Subject: MHI's Responses to US-APWR DCD RAI No. 728-4534 REVISION 2 (SRP 18)

Responses to Request for Additional Information No. 728-4534
REVISION 2

US-APWR Design Certification

RAI NO.: NO. 728-4534 REVISION 2
SRP SECTION: 18.1 - HUMAN FACTORS ENGINEERING
APPLICATION SECTION: 18.01 – 18.1 PROGRAM PLAN
DATE OF RAI ISSUE: 04/04/2011

Figure 1 HFE Team Project Organization

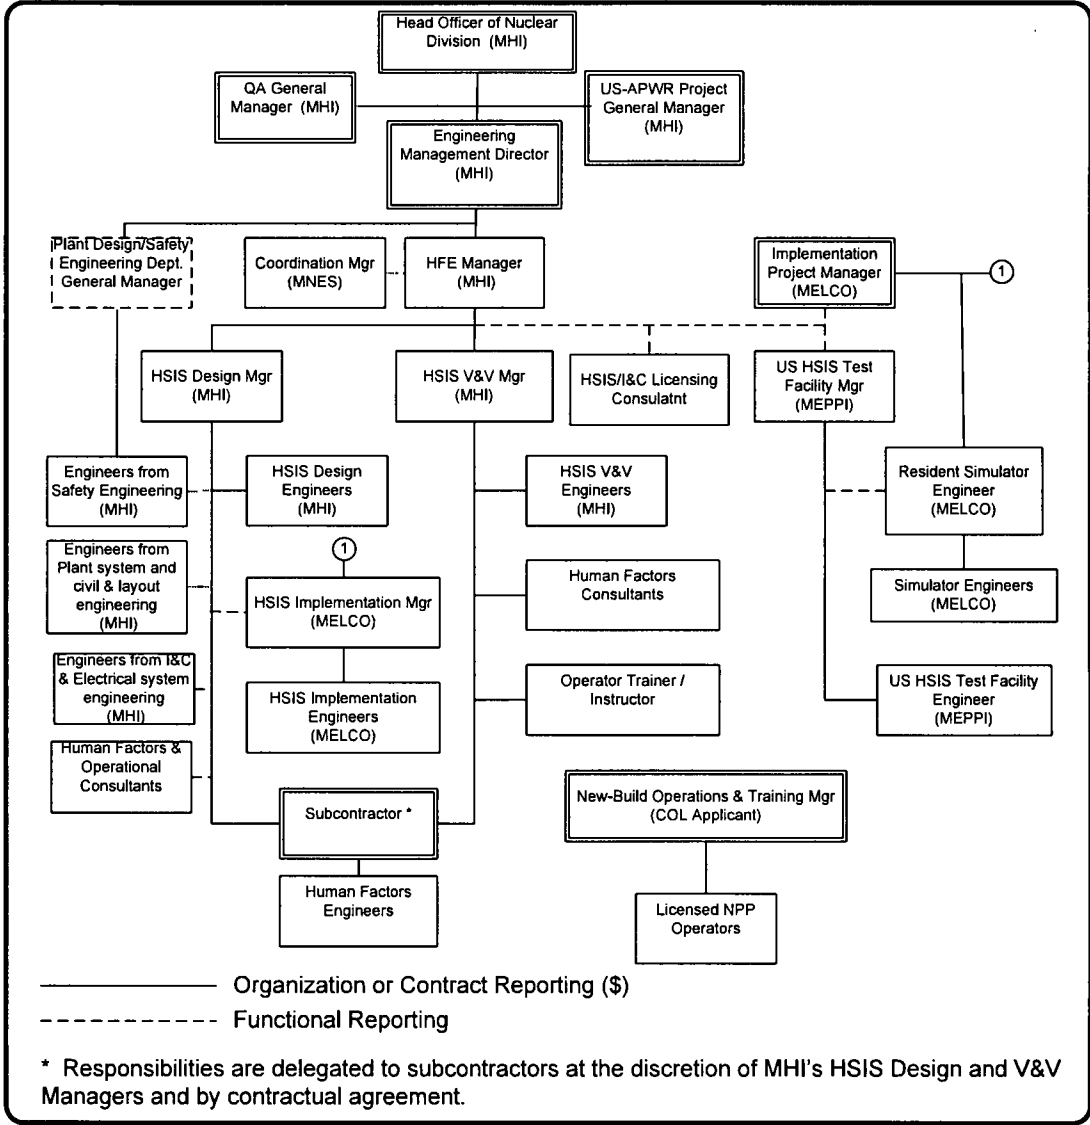
The diagram in DCD Figure 18.1-1 does not show how the HFE design team fits into the larger design team and the US-APWR project.

MUAP-09019, Section 3.2, Figure 1 provides an organization chart which includes both organizational and functional relationships but only shows the organization up through project manager positions. It is unclear how they fit in the larger engineering organization. RAI 295-2341, Question 18-9 requested this information. The response (UAP-HF-09225) stated the organization placement and authority of these teams is controlled by the "Quality Assurance Program . . . (PQD-HD-19005)." This document shows the high level organization but does not connect that organization with the organization described in MUAP-09019.

- Describe the management levels between the project manager described in MUAP-09019, Figure 1 and the management position described in the QA program.
- Include or reference within the DCD the information in MUAP-09019 and this RAI response so more detailed organizational information is available to illustrate how this criterion is met.

Figure 1 of MUAP-01019 will be revised as per shown in Attachment 1, and Attachment 2 Figure 2 of HFE team organization in the MHI engineering and design organizations will be added to MUAP-09019 Part 1, Section 3.2, showing the HFE team organization in the MHI engineering and design organizations.

DCD Figure 18.1-1 will be replaced with Figure 1 in MUAP-09019 Part 1 to clarify the organization.

Figure 3 Engineering work process and integrations flow between HFE team and plant design organizations

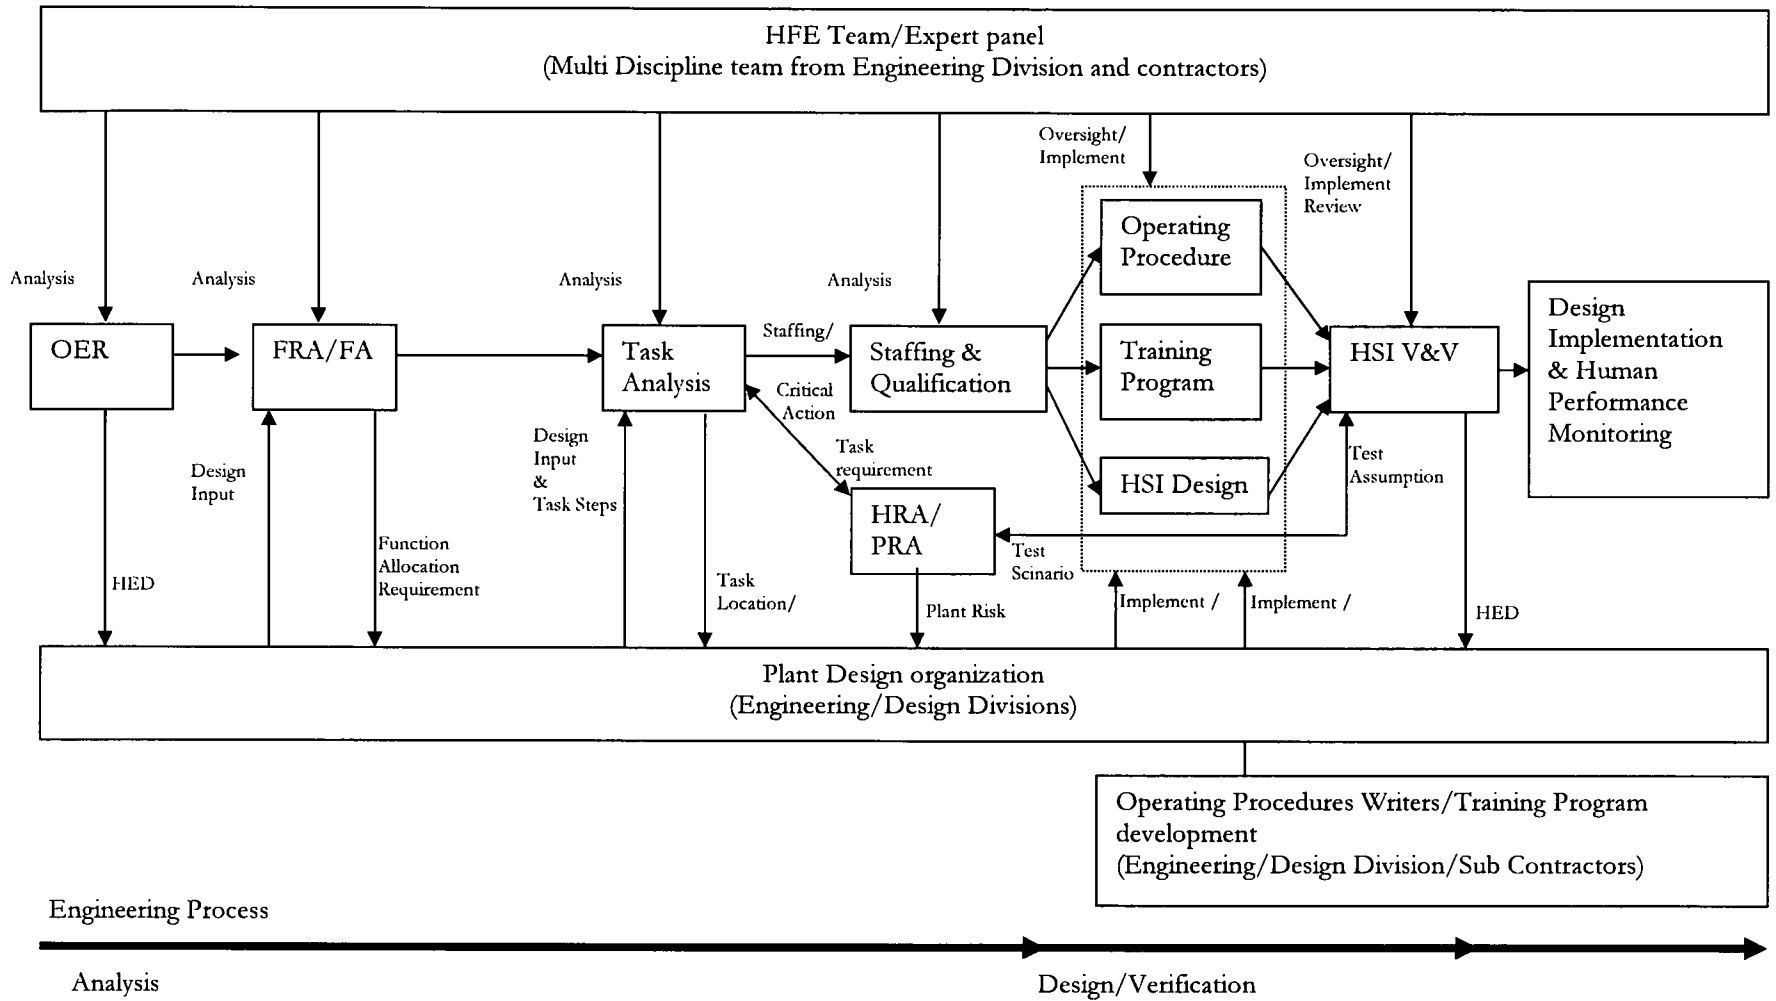
The MHI response to RAI 295-2341, Question 18-13, describes the HED process. The staff acknowledges this as one process management tool but this tool does not address the responsibilities listed in criterion 2.4.3(1).

- Provide the title of working level procedures that control work flow, work priority, work review, describe interfaces with project management, and describe interfaces with supporting technical groups.
- List the key data bases, forms, and other tools contained in these procedures that are used to facilitate proper implementation of the procedure.
- Provide a flow chart of the engineering process that includes process feedback, issue disposition, independent reviews, and supporting technical reviews.

Figure 2 shows the HFE milestone and critical checkpoint in embedded in the plant design, procurement, constructions and operation. Figure 3 show engineering work processes and integrations with plant design organizations. Arrow shows critical checkpoint which indicates each activities milestones and relations with other HFE elements.
